SAVE SUNSET BOULEVARD - EIR COMMENTS ON 8150 SUNSET

In reference to City Case No. ENV-2013-2552-EIR

Please enter the following comments on the Draft Environmental Impact Report (EIR) for the proposed project at 8150 Sunset Boulevard in the City of Los Angeles, California into the public record, and address each one.

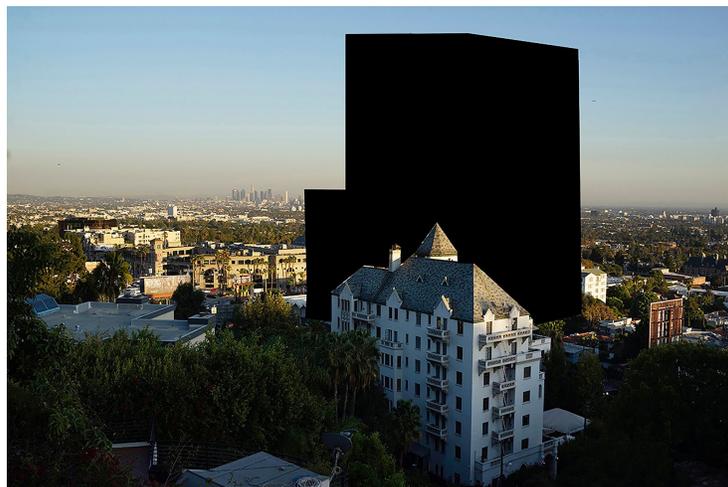
Below is an illustration of how completely out of scale the proposed 220 foot building is with the 2-8 story context of the neighborhood.
